**UNITED STATES ENVIRONMENTAL PROTECTION AGENCY**  
**REGION III**  
**841 CHESTNUT BUILDING**  
**PHILADELPHIA, PENNSYLVANIA 19107**

Re: Revised Phase II Remedial Investigation Review  
Hunterstown Road Site

Required  
Deep  
Boring

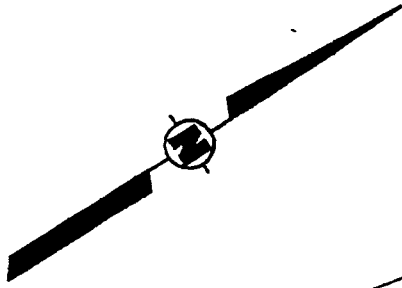
EPA requires one boring near drum burial area one as shown in the attached figure. The soil and bedrock interface has been tested by borings around the perimeter of the unit. A major source of VOCs has not been discovered, yet a significant source must be present to produce the observed ground water contamination plume. This boring is to determine if a source of immiscible VOCs is present in the shallow zone bedding plane bedrock fractures that are in communication with drum burial area one. The boring will be to 10 feet below all of the stratigraphic units that subcrop in the burial area. Hollow core samples must be taken and checked for VOCs by reading with an HNU. If Hnu readings are positive the section of the core should be sampled and analyzed for VOC's.
